12 November 2025

Department of Planning Housing and Infrastructure NSW
Attention: Ms Michelle Niles, Specialist Planner, Planning Assessments

Planning Submission For: (Strata Plan 21252) 1 Tewkesbury Avenue, Darlinghurst
Proposal: Mixed use development with in-fill affordable housing, 164 - 194 William Street, Woolloomooloo

Figure 30: Proposed Built Form

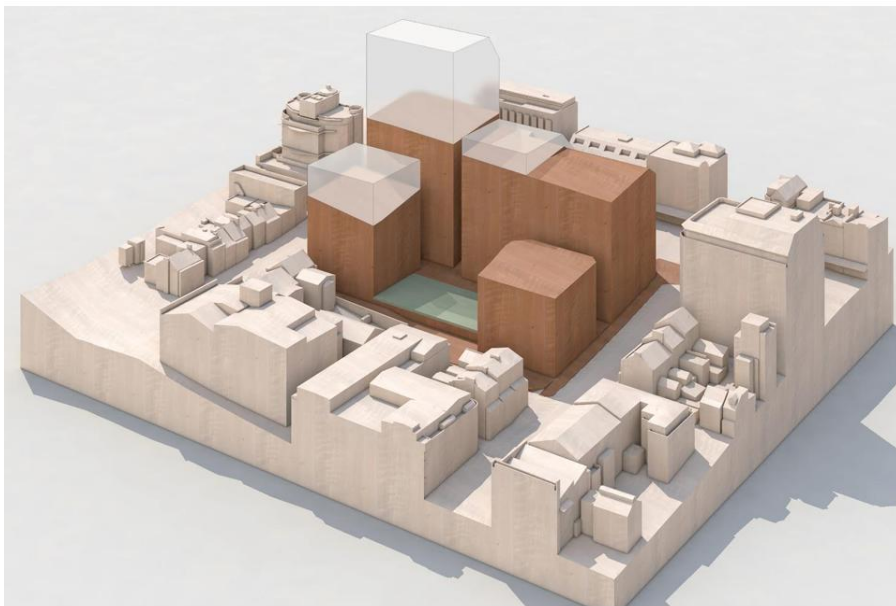
The DA does not present a scale consistent with detailed urban design and planning expectations for the area nor address the character objectives in terms of sympathising with local heritage, lower scales and valuable fine grain. No reasonable consideration is given to the impact of the scale and widths on the surrounding HCA.

The proposal is much higher than anything around and this is evident in the models of the scale within the documentation such as the following from the EIS. This does not show a stepping or scaling down with the topography (as suggested in the EIS) and is not considered contextually considerate or responsive. It is evident as to what the resulting impact and appearance would be from the Harbour, the area and from other properties.
